Desert Tortoise Preserve Committee, Inc.
4067 Mission Inn Avenue, Riverside, CA 92504
Telephone: (951) 683 – 3872 / Email: dtpc@pacbell.net
Web site: www.tortoise-tracks.org

RE: **Formal comments regarding the Draft Desert Renewable Energy Conservation Plan (DRECP) and EIR/EIS**

TABLE 1. Desert Tortoise Preserve Committee, Inc. Comments on DRECP Draft EIR/EIS

Appendix I: Images Comparing Land with Planned Development to the Area Proposed for Mitigation

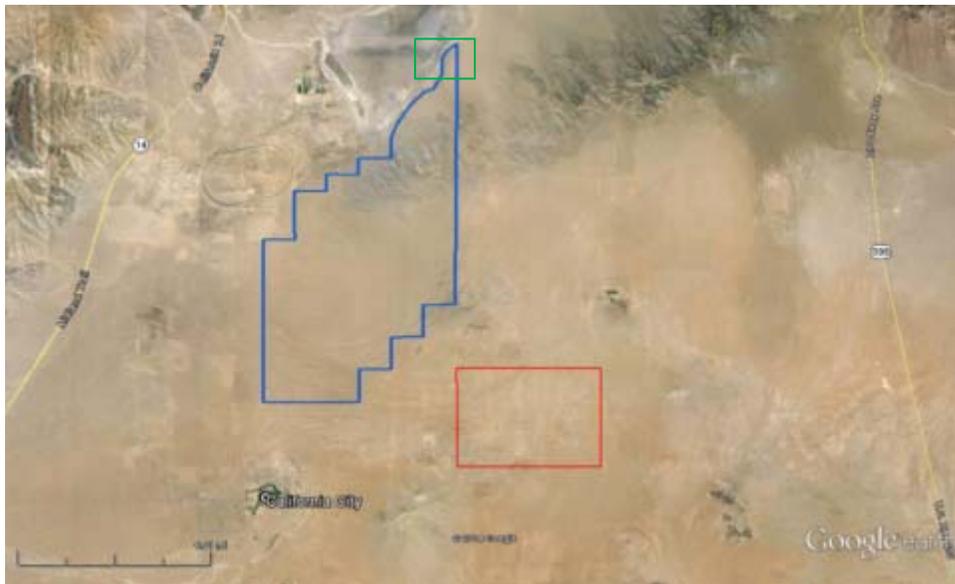
Comment Number	Section Number	Figure Number	Table Number	Page Number	Comment and/or Reference
					<p>However, much of the area which the plan proposes for acquisition as mitigation land (Conservation Planning Areas) in the Peerless Valley, southwest of California City is highly degraded, fragmented, and isolated from existing conservation areas like the DTRNA and West Rand Mountains DWMA. Examples of this are the lands covering the Eastern part of California City. These areas have multiple unpaved roads (in some places every 200-300 feet), as well as other parts of partially-developed infrastructure. These areas do not fulfill any of the requirements that the DRECP sets for mitigation lands, yet these constitute a large proportion of the lands that the DRECP proposes as mitigation land</p> <p>At the same time, the Preferred Alternative designates 1,250 acres of high quality desert tortoise habitat in the DTRNA, and in the West Rand Mountains DWMA, as DFAs. See attached Appendix I</p> <p>We recommend that the DRECP designate higher quality desert tortoise habitat as Conservation Planning Areas, maintain the conservation status of the lands in the DTRNA and DWMA, and designate low quality, highly degraded land as DFAs.</p>

Appendix II: Overlap between the Preferred Alternative and Areas Designated as Conservation Lands in the preferred Alternative According to DRECP Publicly-Shared Maps

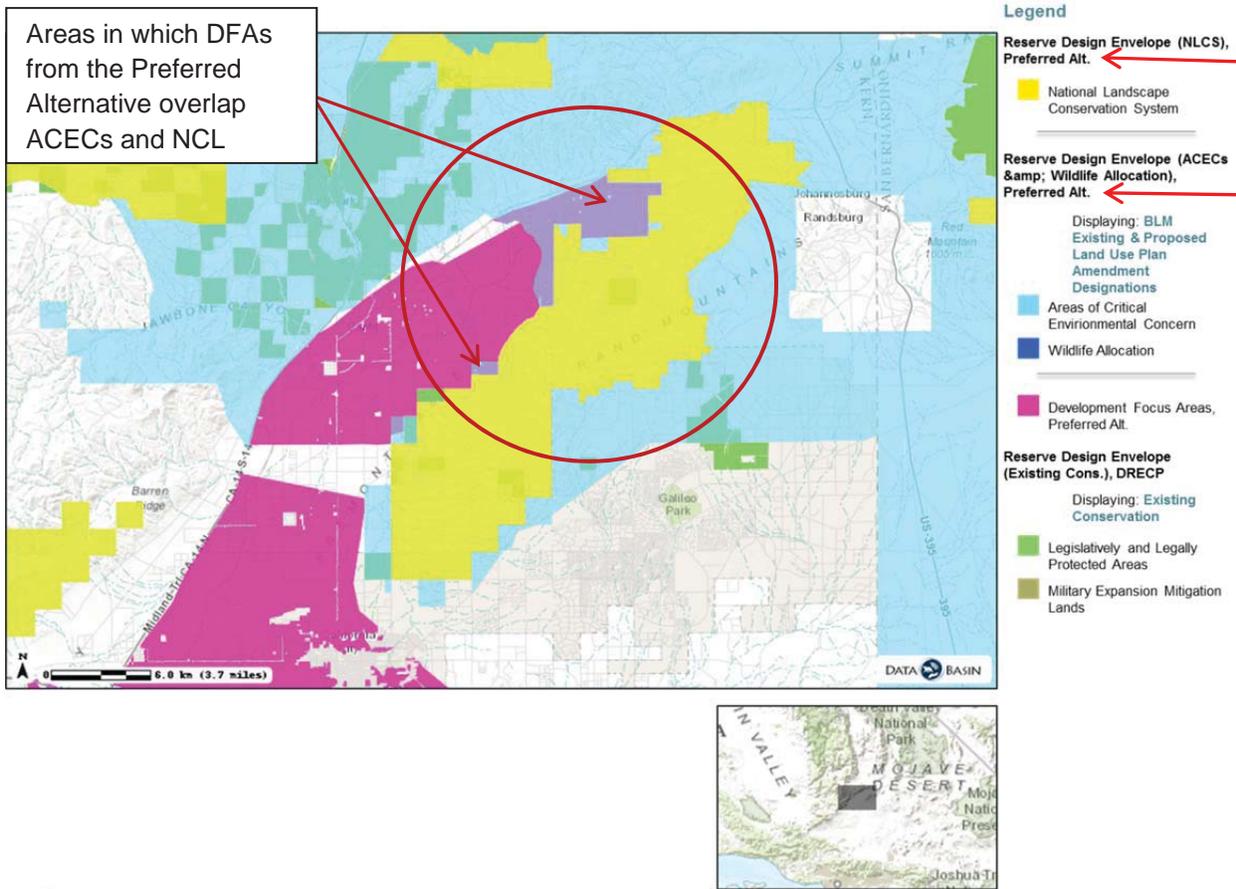
58	II.3.2.3.4.2		II.3-50	II.3-382 II.3-426	<p>The maps for the Interagency Preferred Alternative designate the northern part of the DTRNA, as well as sections of the Eastern part of the Fremont-Kramer ACEC, as Development Focus Areas. The maps provided to the public also designate the same areas as ACECs.</p> <p>According to the DRECP, Volume II: II.3.2.3.4.2 Conservation and Management Actions > Conservation and Management Actions in Areas of Critical Environmental Concern, first bullet point: "Renewable energy and ancillary facilities are not allowed in ACECs". This is reiterated in Table II.3-50: CDCA Plan and DRECP Preferred Alternative Crosswalk. See our attached Appendix II.</p>
59	II.3.2.4.1			II.3-425	<p>The REAT should provide the public with accurate maps that do not contradict the Draft EIR</p> <p>The Draft EIR states that "...while MUC L [limited] lands may be managed similarly to DRECP conservation lands, MUC L lands do not automatically become conservation lands-they may end up in a variety of different DRECP allocations from DFAs to NLCs,".</p>
